Subject: RE: O8W-PM [redacted] - Bucks Creek 1101 Phase 1,2&3 - Pre-Engineering Meeting

# Bucks Creek 1101- PM# [REDACTED] Overview Map

Subject: O8W-PM [REDACTED] Bucks Creek 1101 Phase 1,2&3 - Pre-Engineering Meeting

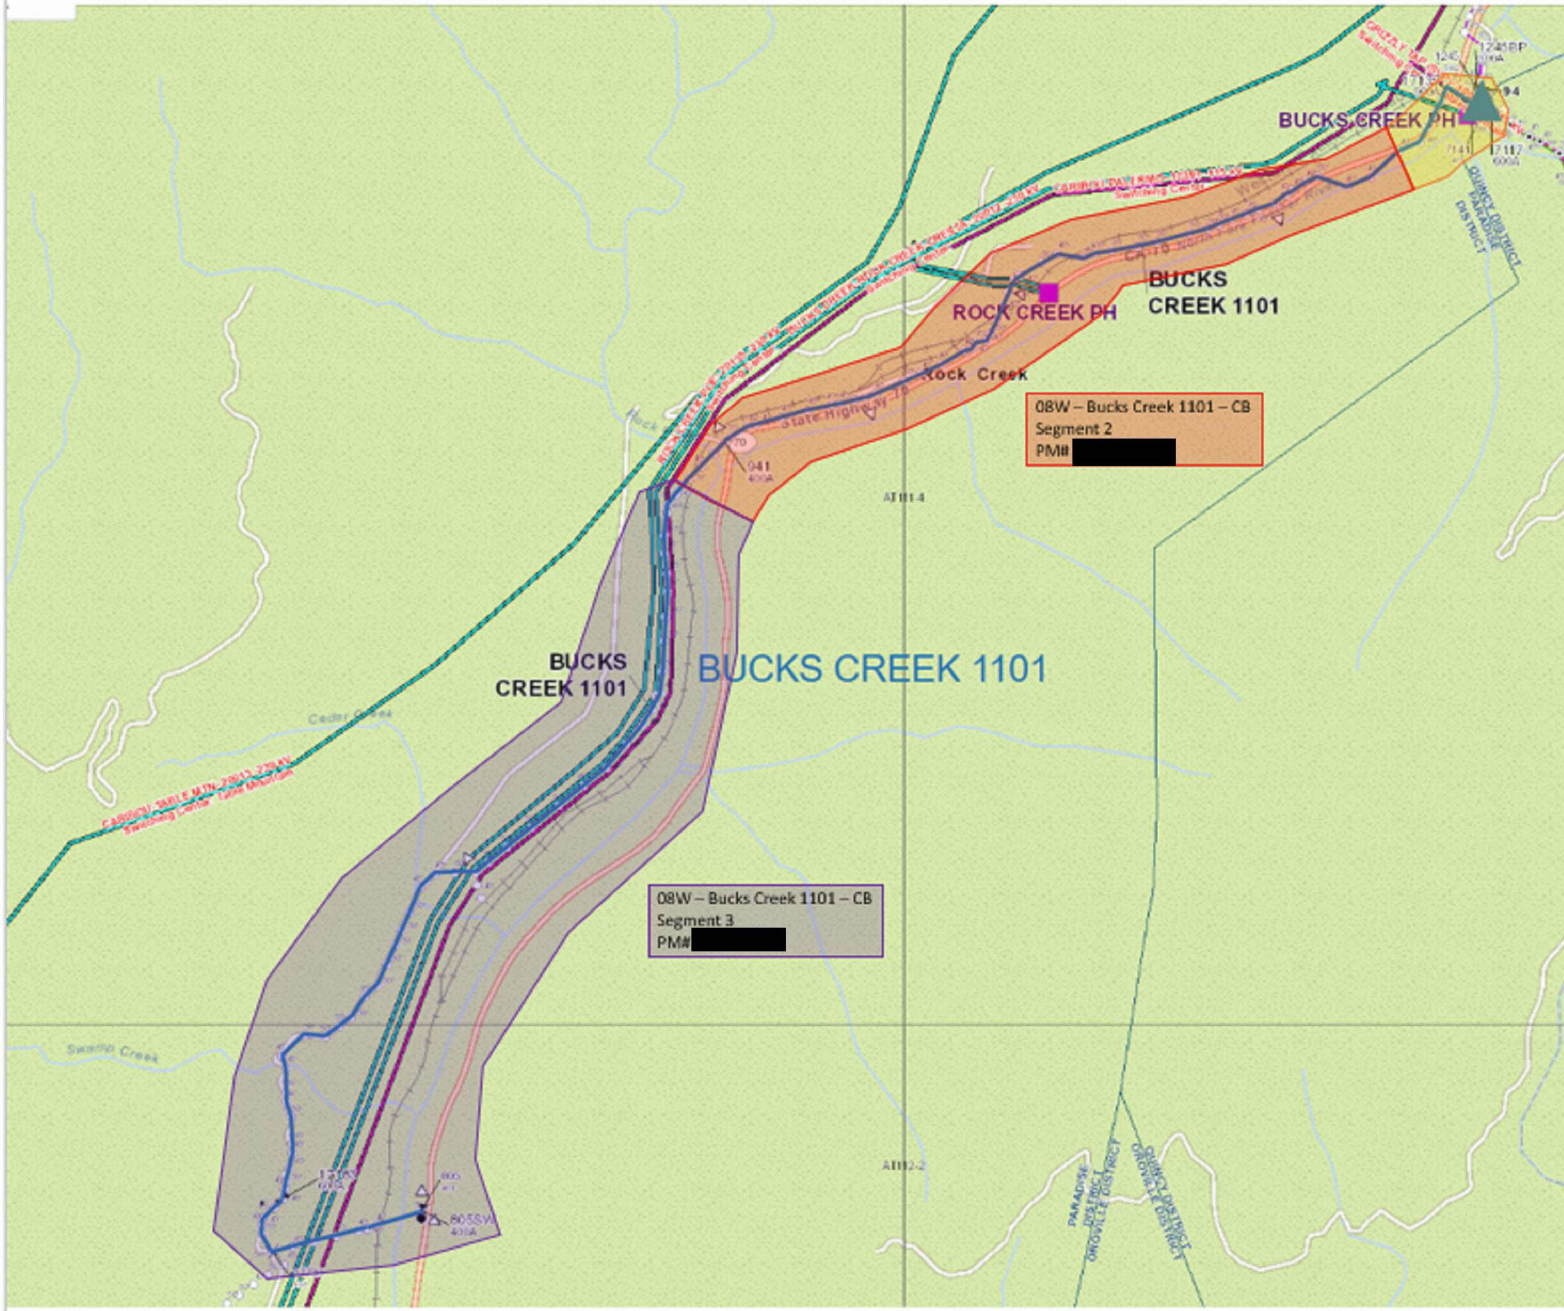
Attached are the 'base-map' limits in a kmz. file. As you will see, we need our base-map to go about ~100' into the tunnel at the south end (see pedestal in picture below....please begin about ~50 beyond this point which is about ~100' beyond the Cresta Dam).

We want to end the base-map at the sign location below which is roughly at MM (Mile Marker) 5.10.
